HEWLETT PACKARD

MANUAL CHANGES

MANUAL DESCRIPTION	
INSTRUMENT:	59301A ASCII to Parallel Converter
SERIAL PREFIX:	1328A
DATE PRINTED:	AUGUST 1973
HP PART NO:	59301-90003

CHANGE DATE: February 26, 1975

Page 8-5, Figure 8-3, 59301A schematic:

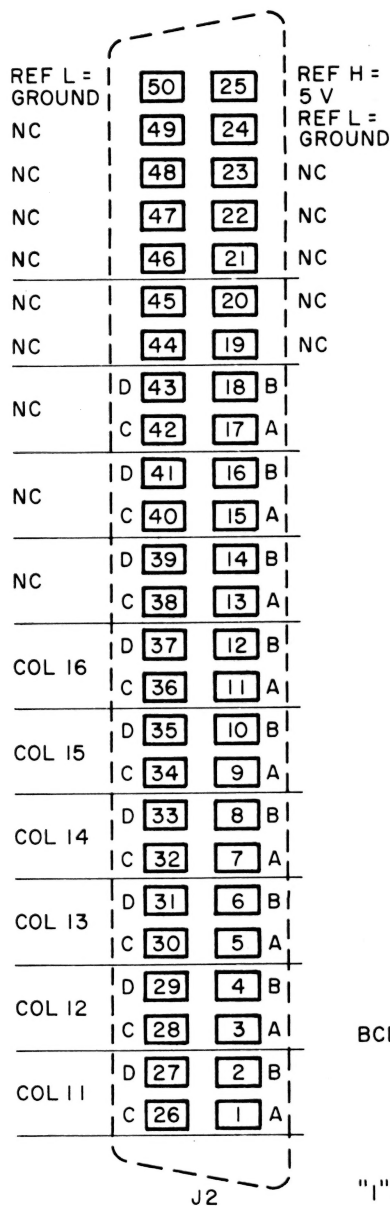
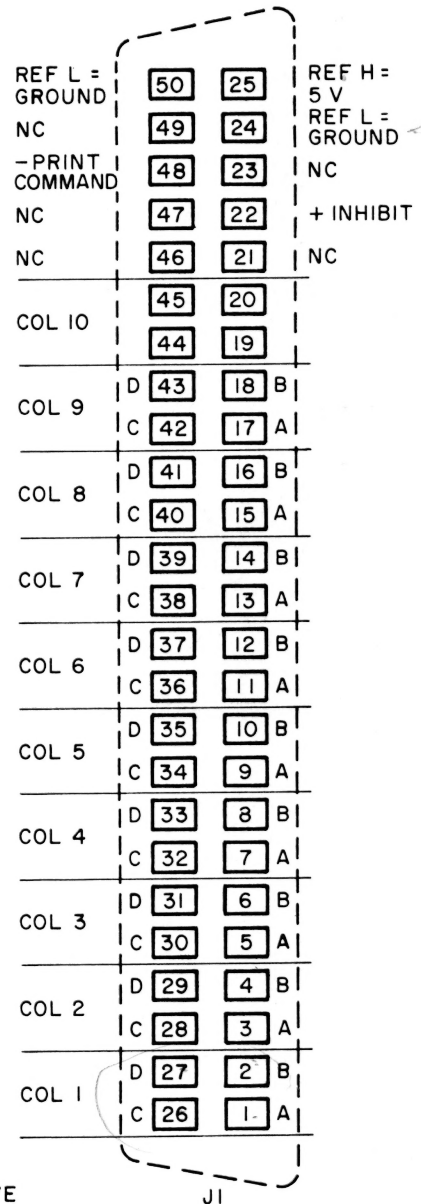
Add to schematic the following J1 and J2 connector drawings — also see Page 3-2, Figure 3-2 for connector location.

BCD WEIGHTS:

A = 1

B = 2

C = 4

D = 8

"I" STATE POSITIVE
